Release note

Dual Lens Tracking Camera: TR535/TR535N

FW version	V0.0.0000.32		
Release date	2025/09/02		
New Feature	1. Dante Ready SDK Preloaded in TR535/TR535N		
	The Dante Ready SDK is now preloaded into the camera, allowing users to enable		
	Dante AV-H through Dante software (Dante Controller).		
	How to use:		
	 Set the Camera theme mode of "Dante" from camera webpage. 		
	 Install Dante Controller to activate "Dante Ready". 		
	https://www.getdante.com/products/software-essentials/dante-controller/		
	(Dante controller is free to download)

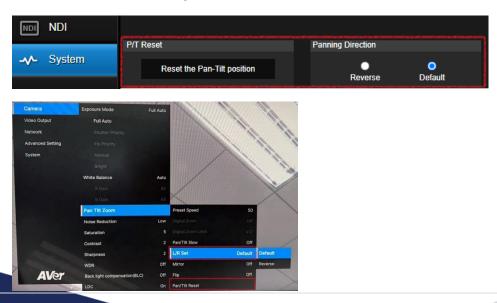
2. Added "P/T Reset" and "Panning Direction (L/R Set)" to the Web Interface and OSD Manual to prepare for the new remote control rollout in Q2, we have added the "P/T Reset" and "Panning Direction (L/R Set)" options to the web interface and OSD manual. The new remote control features a simpler design, removing two buttons and relocating their functions to the web interface and OSD manual.

Both the current and new remote controls will be fully compatible with the camera. Please see the new remote control design below.
